September 10, 2020

GMU Project 17-206-02

Subject: Geotechnical Review of Precise Grading Plans, Dana Point Harbor Parking Structure, 24650 Dana Point Harbor Drive, City of Dana Point, California

GP0.1

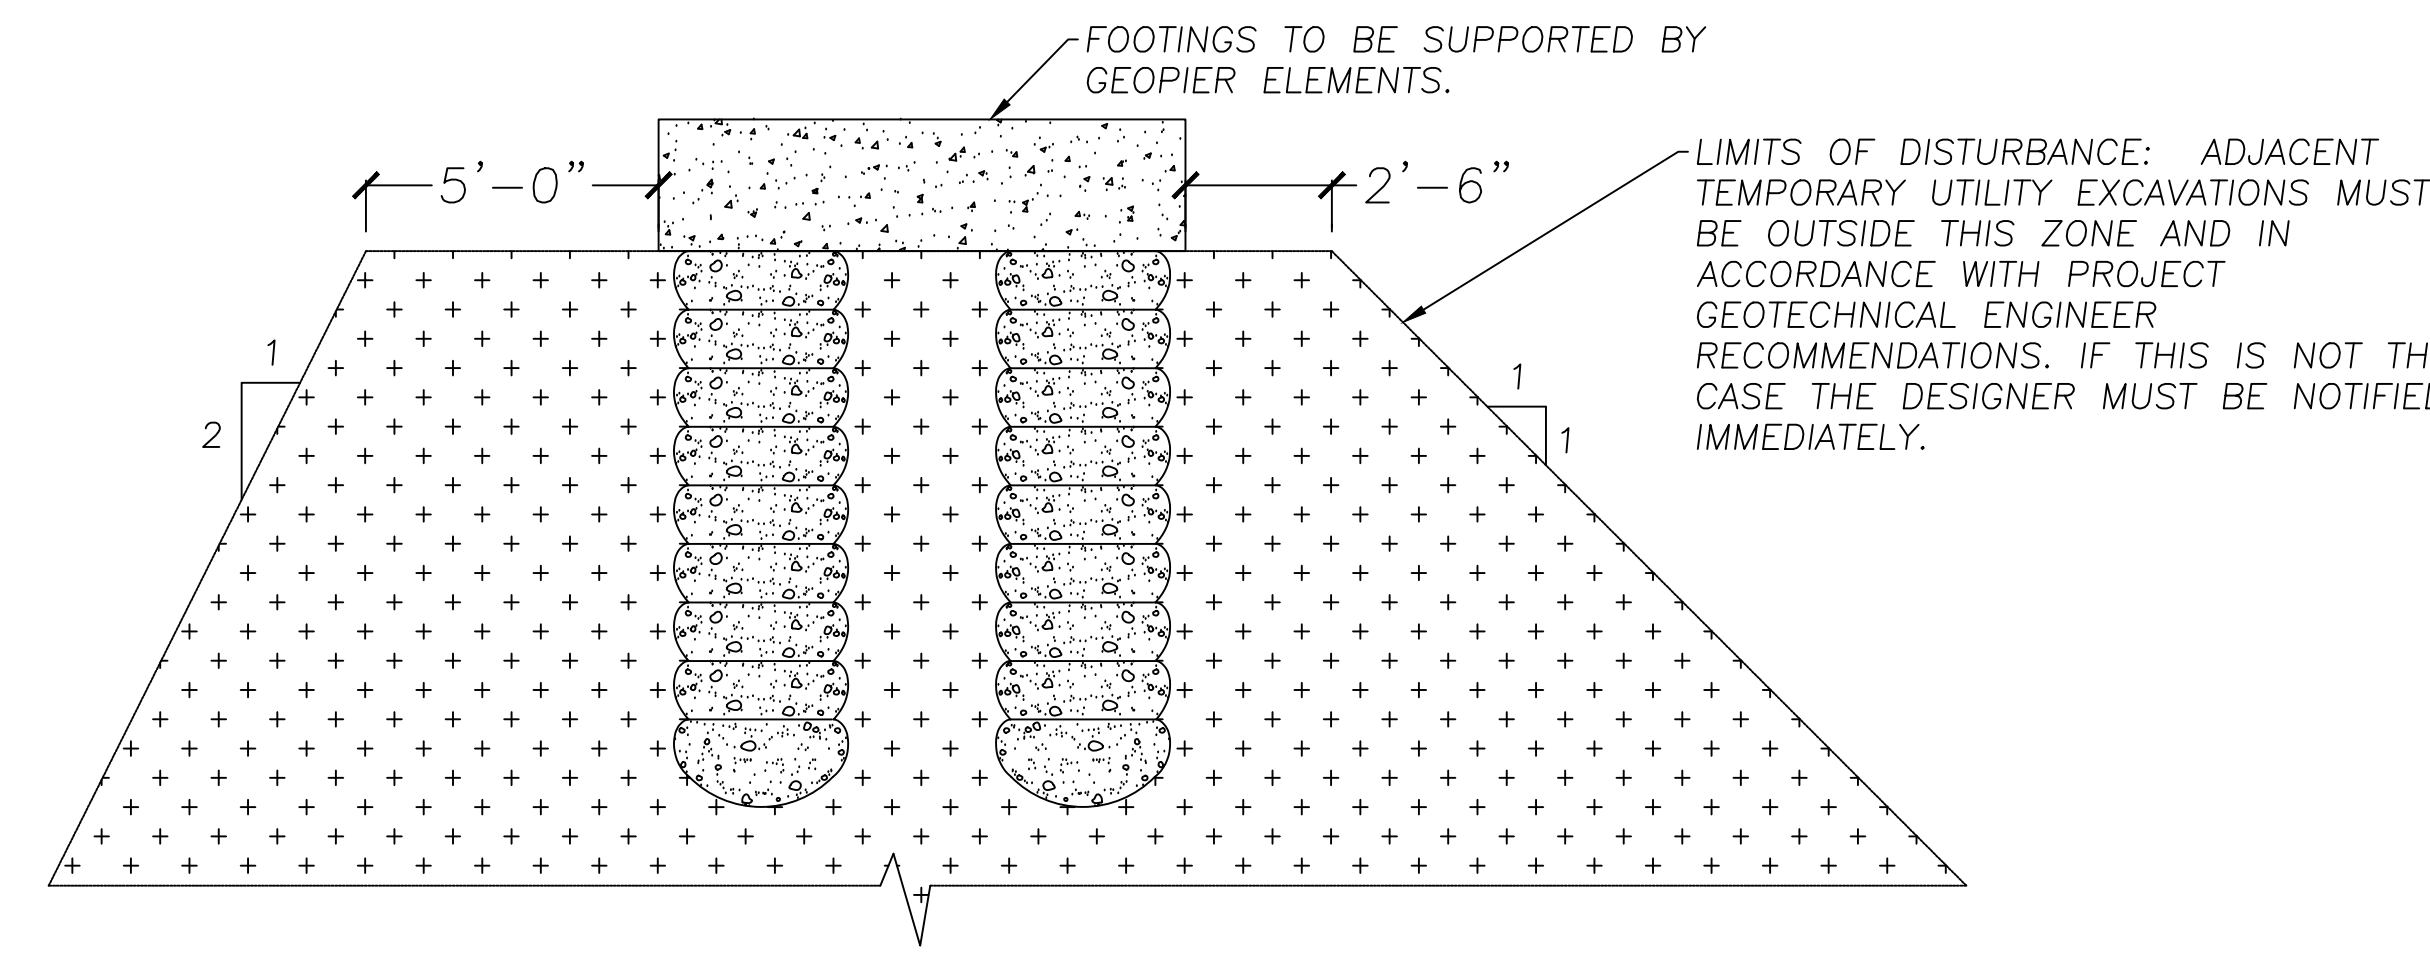
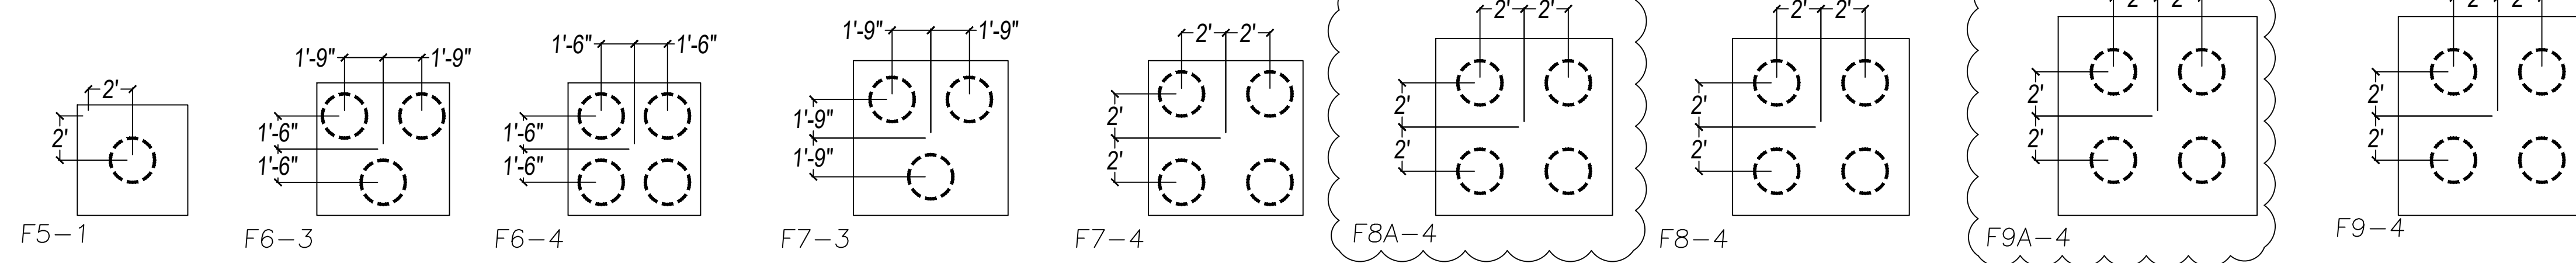
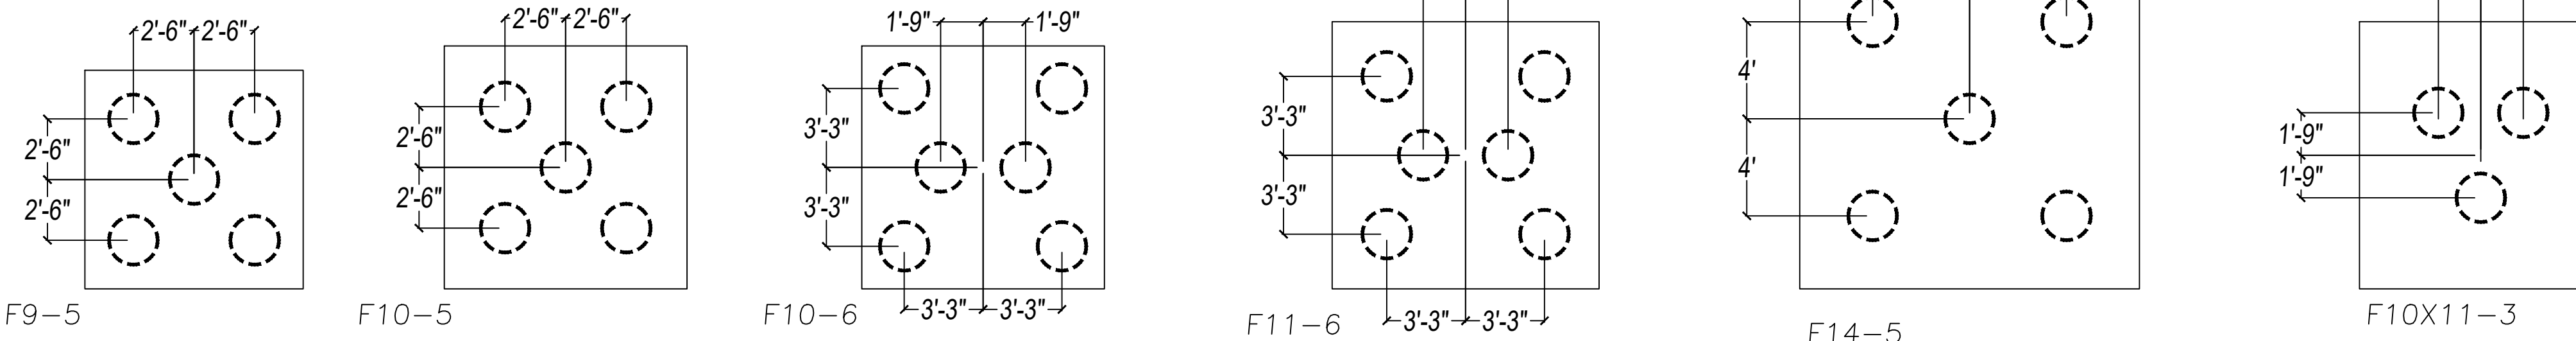
2.015	Geotechnical Review- PKG19-1202 Ryan Rose	Geotechnical/Geology Check List	Footing details for the F8A-3, F9A-3, F10x30 and F24x32 should be provided on the plans by WGI. *** 2nd Submittal - Response is not acceptable. The WGI plans in the second submittal have the same date as the plans that were in the first submittal. Details were not added to Sheet GP0.1 for F8A-3, FA9S-3 F10X30		Not Satisfied

#	Review	Category	Comment	Applicant Response	Status	File Name & Page
2.017	Geotechnical Review- PKG19-1202 Ryan Rose	Geotechnical/Geology Check List	<p>and F24x32.</p> <p>Note 1 below the table on Sheet GP0.1 of the WGI plans states that the Geopier shall reach bedrock. The geotechnical report states that the Geopier should extend a minimum of 12 inches into bedrock and be verified by the project geotechnical engineer. The note should be revised per the geotechnical consultant's recommendation.</p> <p>*** 2nd Submittal - Comment will be marked as satisfied upon confirmation the Geopiers will extend down to competent bedrock, i.e. through any soft, weathered bedrock.</p>		Not Satisfied

2.017	Geotechnical Review- PKG19-1202 Ryan Rose	Geotechnical/G eology Check List	Note 1 below the table on Sheet GP0.1 of the WGI plans states that the Geopier shall reach bedrock. The geotechnical report states that the Geopier should extend a minimum of 12 inches into bedrock and be verified by the project geotechnical engineer. The note should be revised per the geotechnical consultant's recommendation.		Required

#	Review	Category	Comment	Applicant Response	Status	File Name & Page
			GP0.1, WGI lists an allowable bearing pressure of 7 ksf. WGI does not, however, state how they arrived at that value. There is no indication on Sheet GP0.1 how this value will be verified. It's worth noting that an allowable bearing pressure of 6 ksf was used in the structural calculations by Culp & Tanner. Note – "Final bearing value" for garage structure must be confirmed by geotechnical consultant and Geopier in their report(s) that will be pre-pared at the completion of precise grading/Geopier construction. The as-graded report(s) must be submitted to the County for review and approval prior to building permit issuance.

1. Sheet GP0.1, Detail #4: Added footing details for F8A-3 and F9A-3 to F8A-4 and F9A-4
2. Sheet GP0.2: Added Detail #4 to include footing details for F24x32, F10x30, and F5-29.
3. All GP Sheets are dated August 31, 2020 in the lower righthand corner for the 3rd submittal.
4. All letterhead pages are dated August 31, 2020 for the 3rd submittal.

The 120 pcf soil unit weight value used in the WGI calculations has been increased to 125 pcf to match GMU's recommendation in our reference (3) report. Please see the corrected unit weight value of 125 pcf on the WGI Geopier 3rd submittal Sheet GP0.1 and calculation pages in the attached Appendix B.
